## Clinton Power Station

Clinton Power Station, Unit 1  
Facility Operating License No. NPF-62  
NRC Docket No. 50-461

Subject: Additional Information Supporting the License Amendment Request to Permit  
Upated Power Operation at Clinton Power Station

### **Additional Information Supporting the License Amendment Request to Permit Uprated Power Operation at Clinton Power Station (Non-Proprietary)**

**Figure 5.1a-1  
Batch Offload SFP Decay Heat Load**

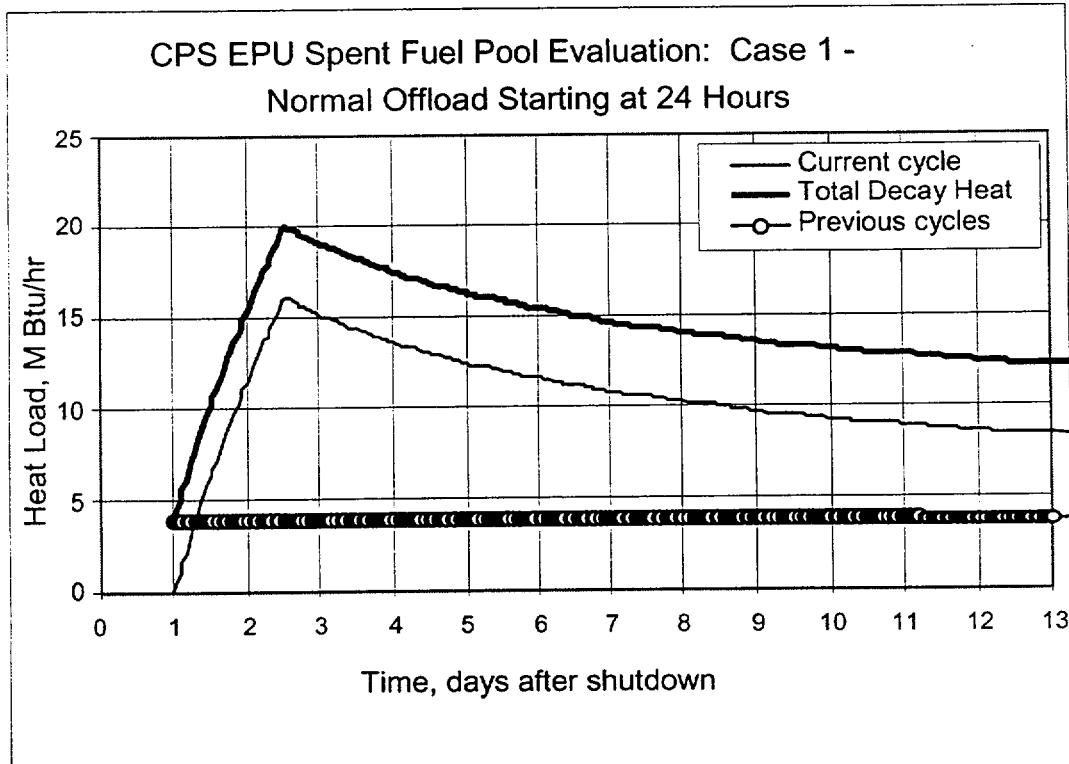
5.1a SFP heat loads and the corresponding peak calculated temperatures during planned (normal) partial and/or full-core offload outages and unplanned (abnormal) full-core offload outages for pre-EPU and EPU conditions. A planned offload is the offload of fuel assemblies to the SFP for any expected (or planned) reason (e.g., refueling outage). An unplanned offload is the offload of fuel assemblies to the SFP due to an unforeseen condition (e.g., unexpected shutdown that includes an offload).

5.1a The following Figures 5.1a-1 through 5.1a-4 show the calculated response of the SFP for partial and full-core offloads for EPU conditions.

**Figure 5.1a-3  
Batch Offload SFP Temperature**

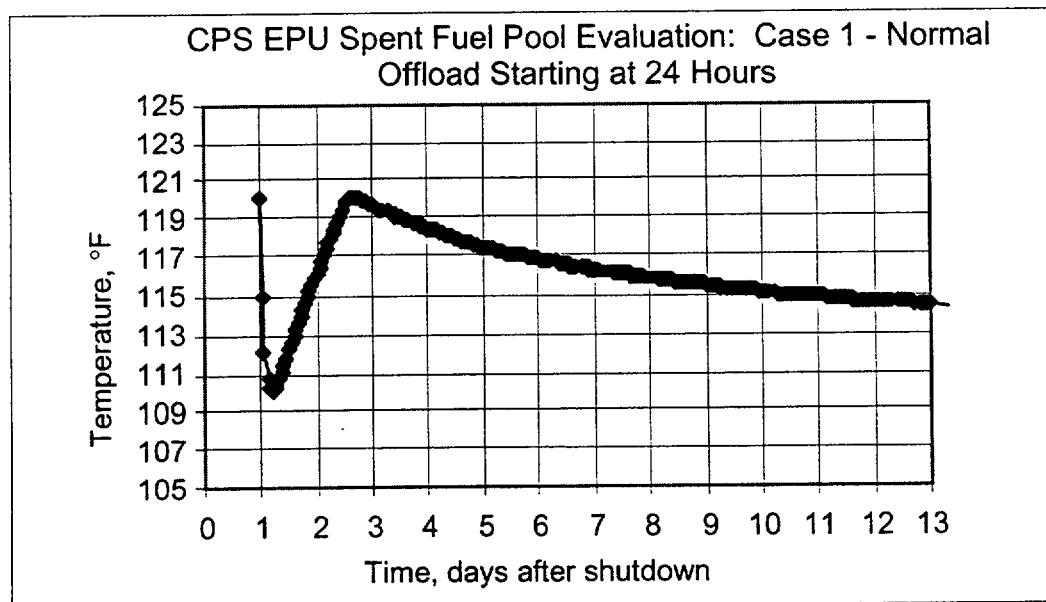
5.1e For the planned refueling outages (with either partial or a full-core offload), if the calculated peak SFP temperature is above 150°F, provide thermal stress analyses to demonstrate that the SFP structure can withstand the new high temperature for the duration of time during which the SFP temperature is above 150°F. Mechanical and Civil Engineering Branch (EMEB) has the primary review responsibility for structural thermal stress analyses.

5.1e As demonstrated in the graphs above (i.e., Figures 5.1a-3 and 5.1a-4), the SFP temperature does not exceed 150°F for the planned refueling outage heat load, for either partial or full-core offload.

**Figure 5.1c-1**  
**Batch Offload SFP Temperature for Accident Condition**

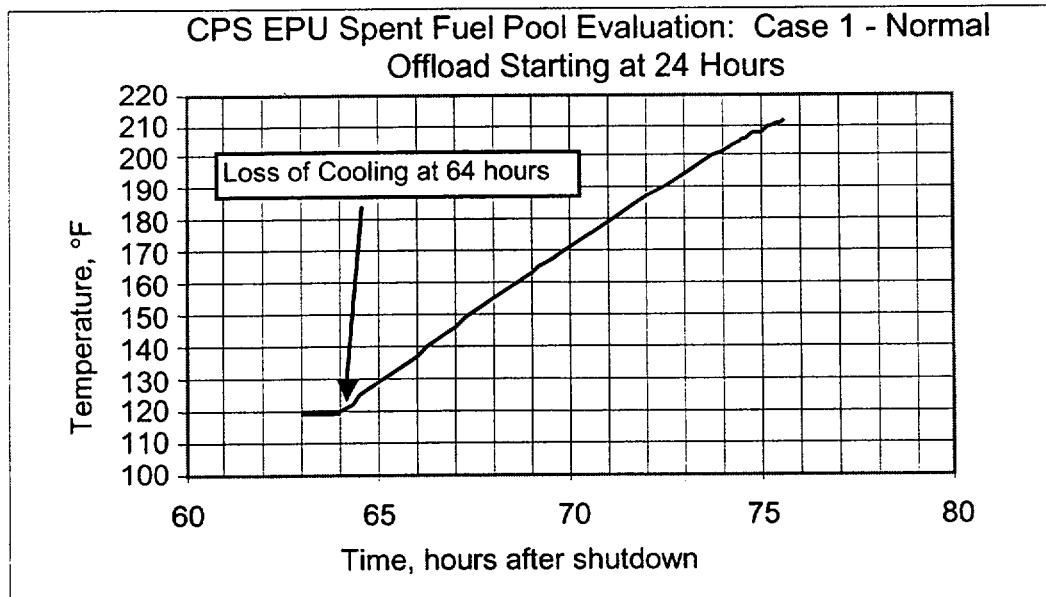
5.1c For the planned refueling outages (with either partial or a full-core offload), discuss how the most severe single failure (e.g., failure of: a FPCC system train, a residual heat removal system train, emergency diesel generator, etc.) has been identified and accounted for in the SFP thermal-hydraulic analyses. (A single failure need not be assumed for the unplanned full-core offload events.)

5.1c The accident conditions are initiated at the peak SFP temperature for partial and full-core offload scenarios, by assuming that the entire FPCCS cooling capacity is lost. The results of the analysis are shown in Figures 5.1c-1 and 5.1c-2.

**Figure 5.1c-2**  
**Full Core Offload SFP Temperature for Accident Condition**

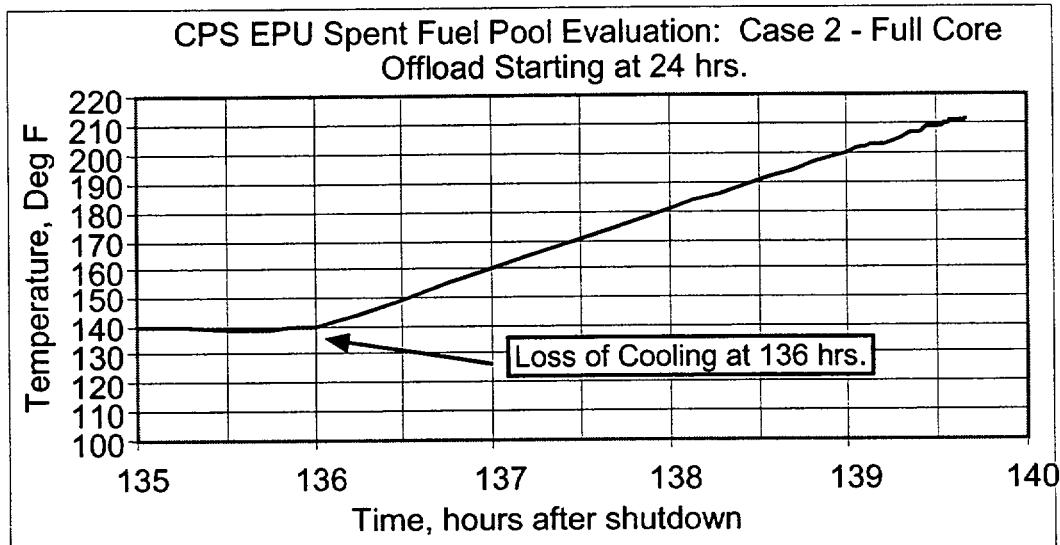
*5.4c Information supporting a determination that there is sufficient time for operators to intervene in order to ensure that the temperature limit of 150°F will not be exceeded.*

5.4c Based on the graph above for the worst case scenario, (i.e., a full-core offload with a complete loss of SFP cooling starting at the peak SFP temperature of 140°F as described in Figure 5.1c-2), the amount of time for operator action to prevent exceeding 150°F SFP temperature is greater than 30 minutes. Since a system malfunction that would initiate a loss of cooling is annunciated in the Main Control Room, sufficient response time remains for the operators to take actions to mitigate the temperature rise.
